# Access Compliance Report

## Public Rights-of-Way

### (Curb Ramps)

Intersection ID: 10353	Main Street: E_35TH_ST	Cross Street: N_MCDOWELL_ST	Location: N
ADA ID: 36D10565D024	Ramp Type: PerpDiag	Initial Pass/Fail: Fail	Overall Compliance: No
Severity Score: 13.75			
Codes/Mitigation Info/Possible Solution		Field Measurements/Component Compliance

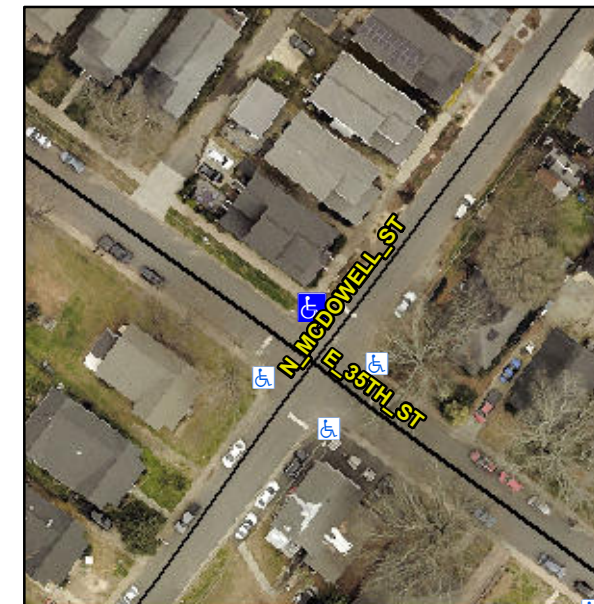
**R304.2.2, R304.5.3**

Compliance	Description	Data	Compliance	Description	Data
N/A	Ramp Length (in)	77.5	No	Ramp Slope (%)	11.9
Yes	Ramp Width (in)	48.0	No	Ramp XSlope (%)	2.3
N/A	Flare Type LT	N/A	N/A	Flare Type RT	N/A
N/A	Flare Slope LT (%)	N/A	N/A	Flare Slope RT (%)	N/A
N/A	Flare Traversable LT?	N/A	N/A	Flare Traversable RT?	N/A
N/A	Landing Length (in)	N/A	N/A	DWS Provided?	N/A
N/A	Landing Width (in)	N/A	N/A	DWS Contrast?	N/A
N/A	Landing Slope (%)	N/A	N/A	DWS Length (in)	N/A
N/A	Landing X Slope (%)	N/A	N/A	DWS Full Width?	N/A
N/A	Landing Curb? (Y/N)	N/A	N/A	DWS Offset (in)	N/A
N/A	Shared Landing?	N/A			
N/A	Gutter Ponding?	N/A	N/A	Gutter Slope (%)	N/A
N/A	Gutter Lip Ht (in)	N/A	N/A	Gutter X Slope (%)	N/A
N/A	Painted X Walk1?	No	N/A	Painted X Walk2?	No
	X Walk 1 Direction	To SW		X Walk 2 Direction	To SE
N/A	X Walk 1 Width (in)	N/A	N/A	X Walk 2 Width (in)	N/A
	X Walk 1 Slope (%)	2.5		X Walk 2 Slope (%)	1.2
	X Walk 1 X Slope (%)	2.3		X Walk 2 X Slope (%)	1.6

**Remove & Replace Curb Ramp With Two New Directional Ramps or Equivalent.**
